N3382A-01C

S E R V I C E N O T E

Supersedes:
N3382A-01B

N3382A PNA Series RF Network Analyzers

Figure 1

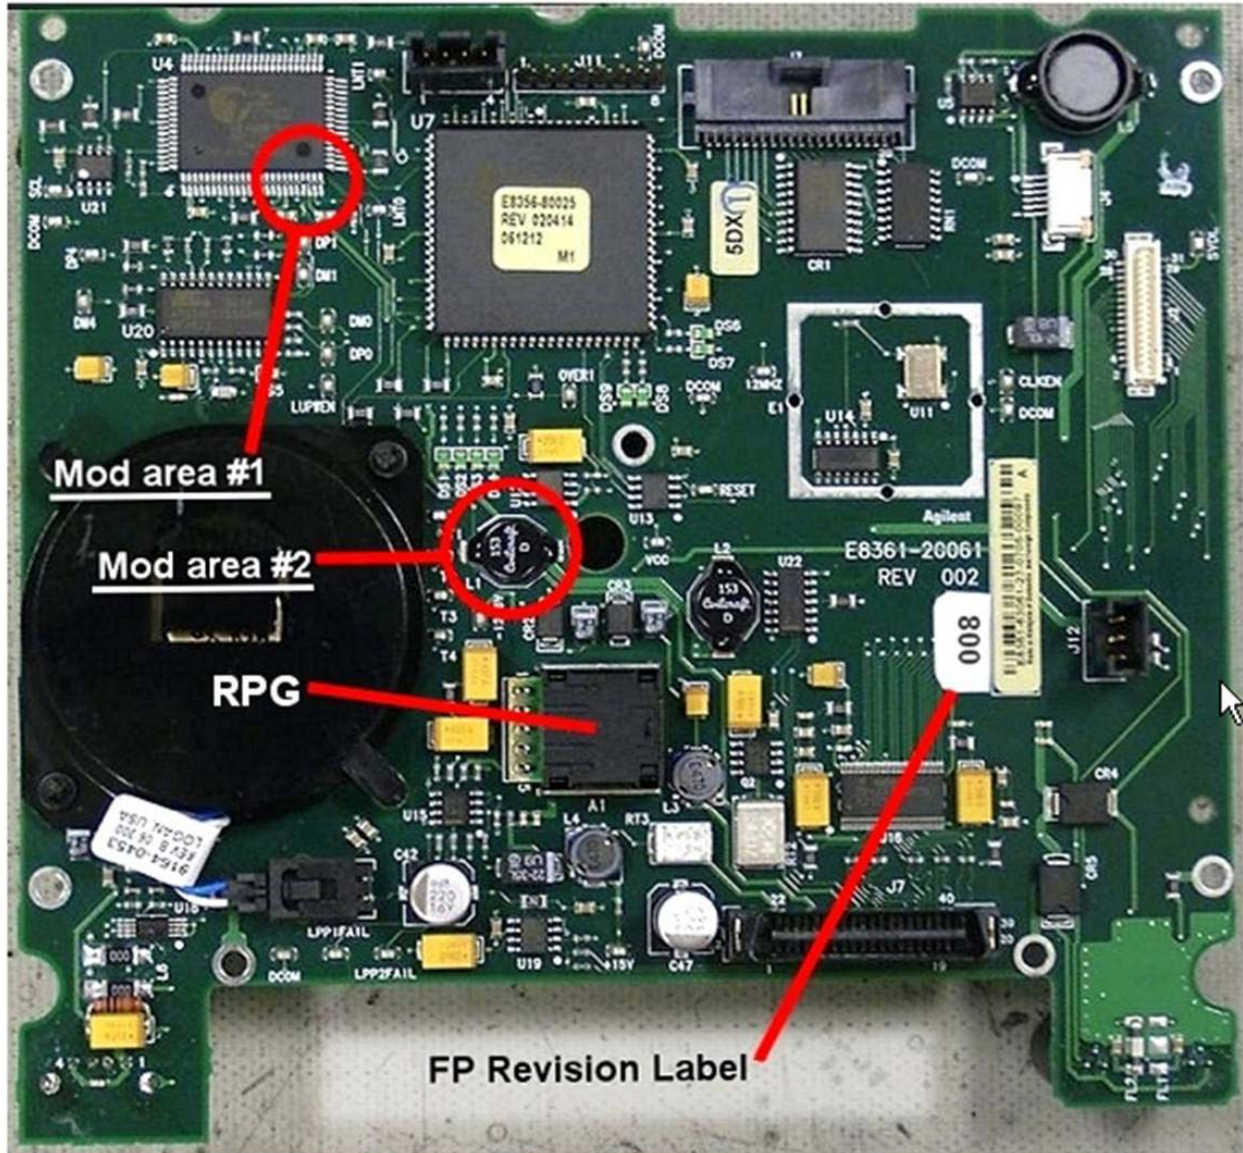
Refer to Figure 1 for the two modification areas to be addressed. Note that while this picture happens to show the FPI board completely removed from the front frame assembly, this is not necessary to perform the required modifications.

- Modification #1 consists of shorting two pins of U4 together with a small amount of solder.
- Modification #2 consist of removing L1.

Figure 2

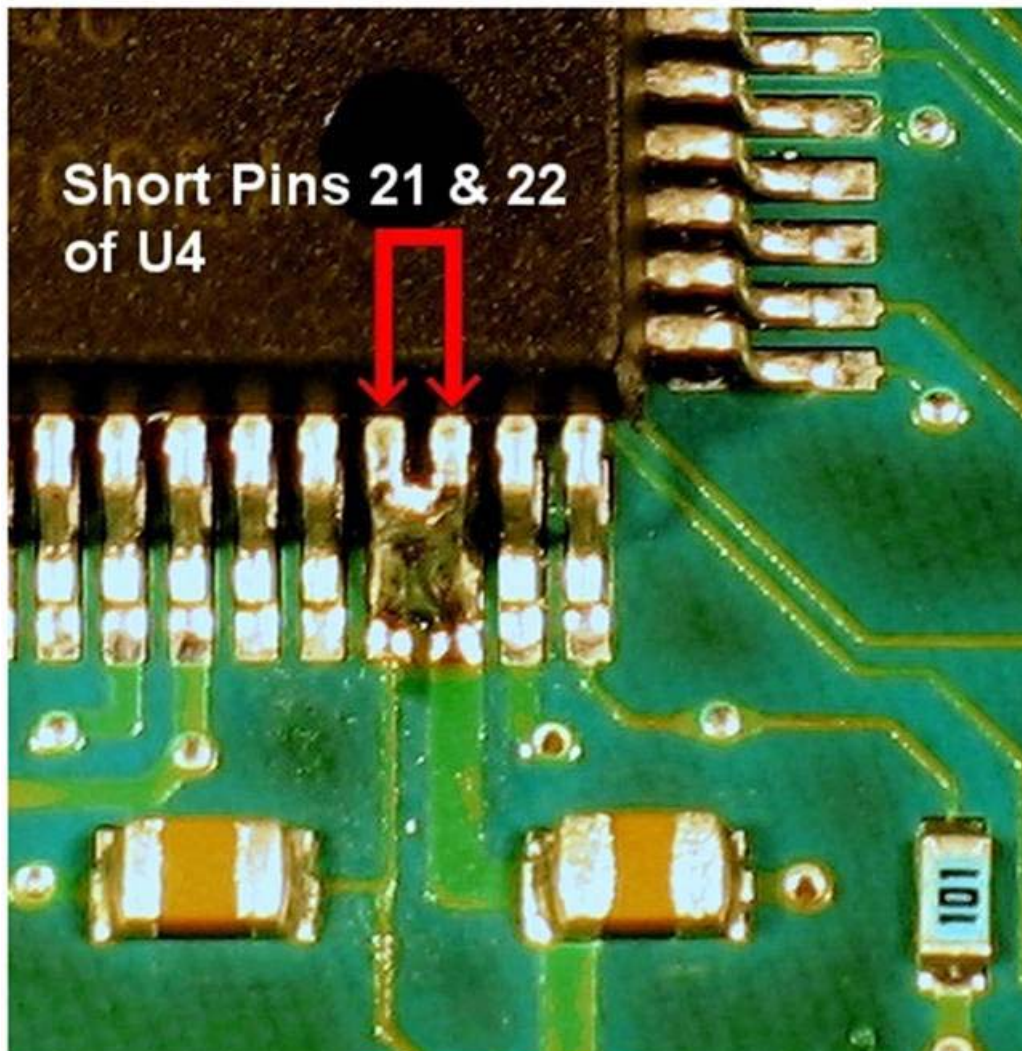
Carefully solder pins 21 and 22 together on U4. Refer to Figure 2 for the exact location. Use care so that no other pins are shorted. Use of a very fine tip soldering iron is recommended and a large work-task magnifying glass is very helpful.

Unsolder and completely remove the black surface mount inductor L1 from the front panel assembly board. This is no longer needed and can be discarded.
